Sutton Courtenay Parish Council

7th October, 2013

**P13/V1832/0 Proposed redevelopment of buildings and land to provide new buildings for storage and distribution (class B8) and ancillary facilities, car and lorry parking, service areas, access and landscape
Land to the west of Didcot Power Station, Sutton Courtenay Lane, Sutton Courtenay
For: Diageo Pension Trust**

Annexe 2

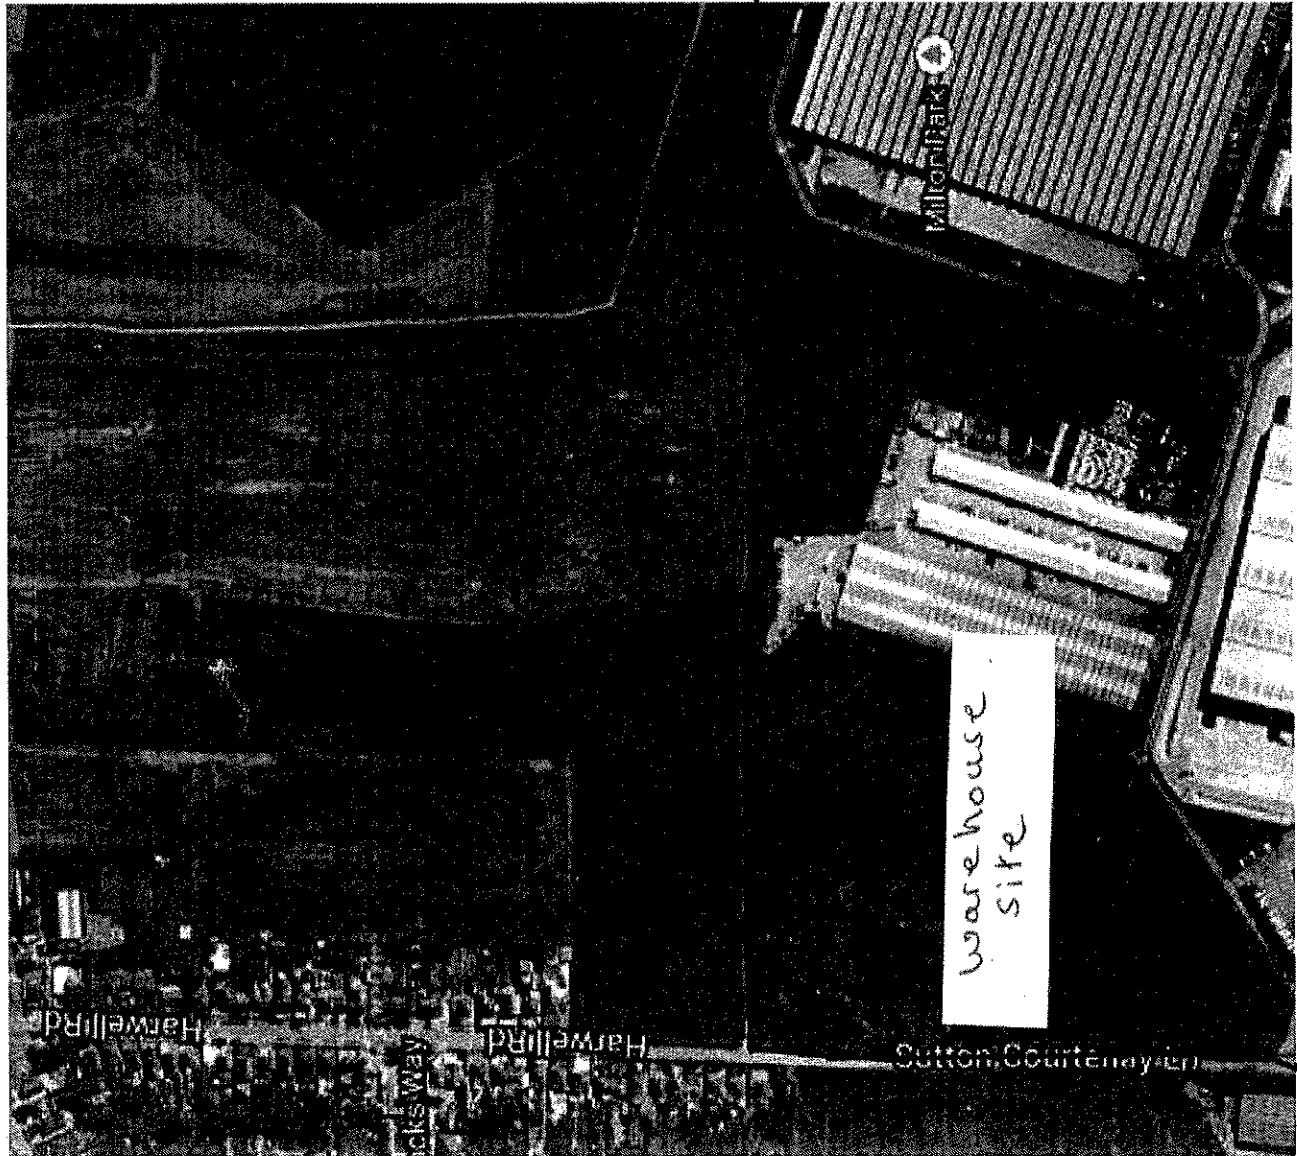
Visualisations that have been done, show the Didcot "A" cooling towers and chimney in place. This is clearly misleading, as these will be demolished in 2014. Annexe 2 which is to scale shows the warehouse in relation to a bungalow in Harwell Road, and the cooling towers. The visualisations too are based on trees having grown for 20 years. This is disingenuous and create a false impression of the current situation, and of what the future position will be. Using Forestry Commission data and taking an Ash Tree as an exemplar it can be shown it would take 112 years for a tree to growth to a height sufficient to screen this building.
